SUBJECT: SURRY UNITS 1 AND 2 - ISSUANCE OF AMENDMENTS RE: F DELTA H LIMIT
AND STATISTICAL DNBR METHODOLOGY (TAC NOS. M81271 AND M82168)

AMENDMENT NO. 170 TO FACILITY OPERATING LICENSE NO. DPR-32 - SURRY UNIT 1
AMENDMENT NO. 169 TO FACILITY OPERATING LICENSE NO. DPR-37 - SURRY UNIT 2

SAFETY EVALUATION BY THE OFFICE OF NUCLEAR REACTOR REGULATION
RELATED TO AMENDMENT NO. 170 TO FACILITY OPERATING LICENSE NO. DPR-32
AND AMENDMENT NO. 169 TO FACILITY OPERATING LICENSE NO. DPR-37
VIRGINIA ELECTRIC AND POWER COMPANY
SURRY POWER STATION, UNIT NOS. 1 AND 2
DOCKET NOS. 50-280 AND 50-281

TS FIGURE 2.1-1

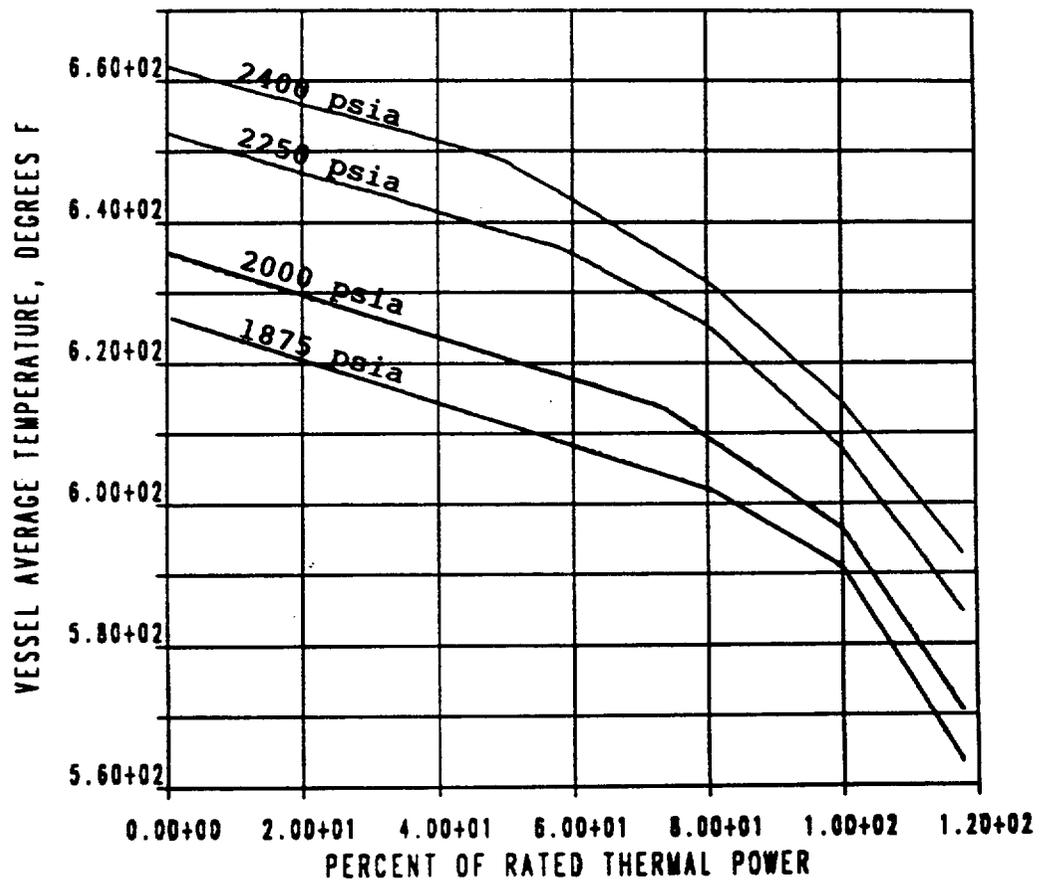
TS Figure 2.1-1 is based on an $F\Delta H(N)$ of 1.62, a 1.55 cosine axial flux shape, and a deterministic DNB analysis procedure including margin to accommodate rod bowing⁽¹⁾. TS Figure 2.1-1 is also bounding for a statistical treatment of key DNBR analysis parameter uncertainties including an enthalpy rise hot channel factor which follows the following functional form: $F\Delta H(N) = 1.56 [1 + 0.3(1-P)]$ where P is the fraction of rated power. TS Figures 2.1-2 and 2.1-3 are based on an $F\Delta H(N)$ of 1.55, a deterministic treatment of key DNB analysis parameter uncertainties, and include a 0.2 rather than 0.3 part power multiplier for the enthalpy rise hot channel factor.

- d. TS Figure 2.1-1 - change to reactor core thermal and hydraulic safety limits to reflect 1.62 F-delta-h.
- e. TS 3.12-3 - change to equation for F(N)-delta-h to reflect F-delta-h surveillance limit; change in line referring to above equation; change to F-delta-h surveillance limit value in discussion of maintenance operation within hot channel factor limits.

TS FIGURE 3.12-8

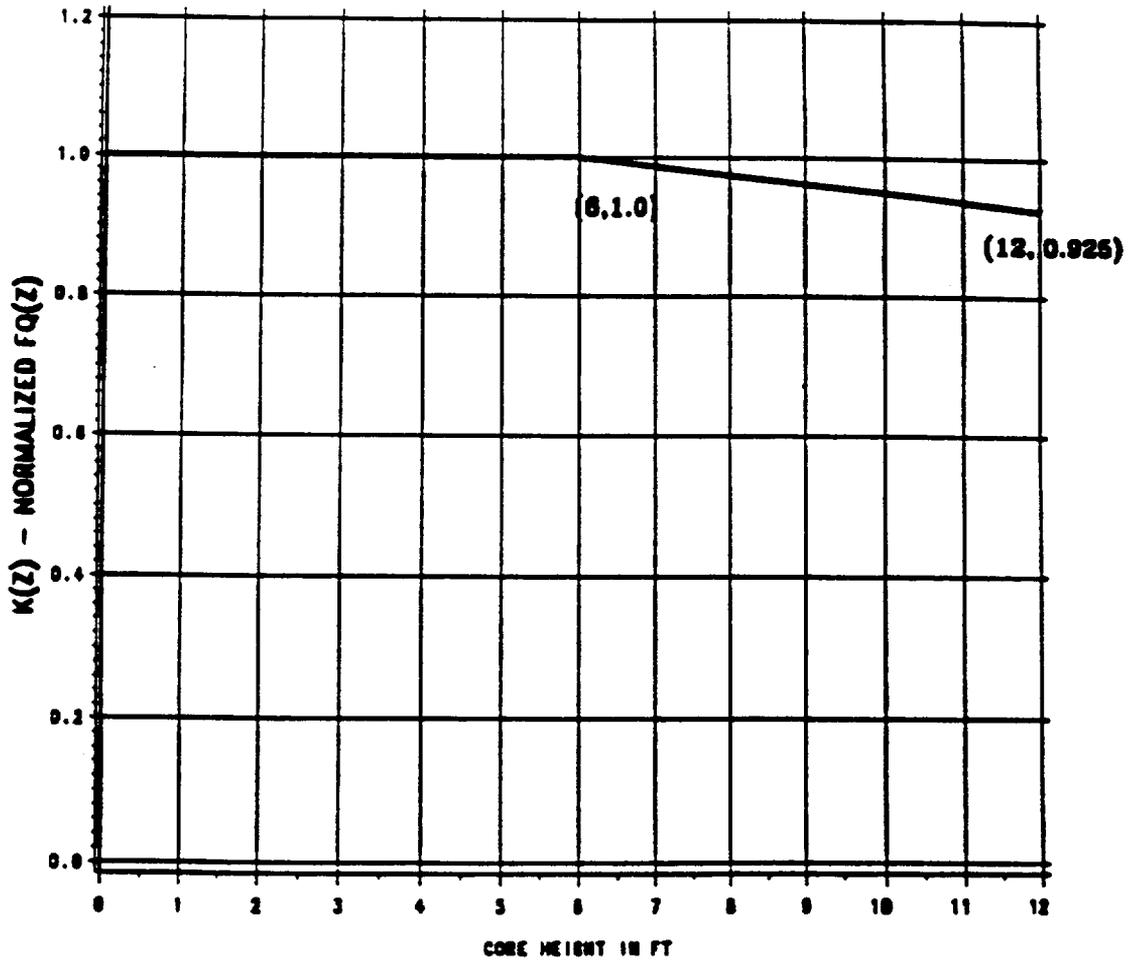
- k. TS 3.12-19 - Bases discussion is added for DNB parameters specified on TS pages 3.12-11 and 3.12-11a.
- l. TS Figure 3.12-8 - change to hot channel factor normalized operating envelope, to reflect changed F-delta-h.
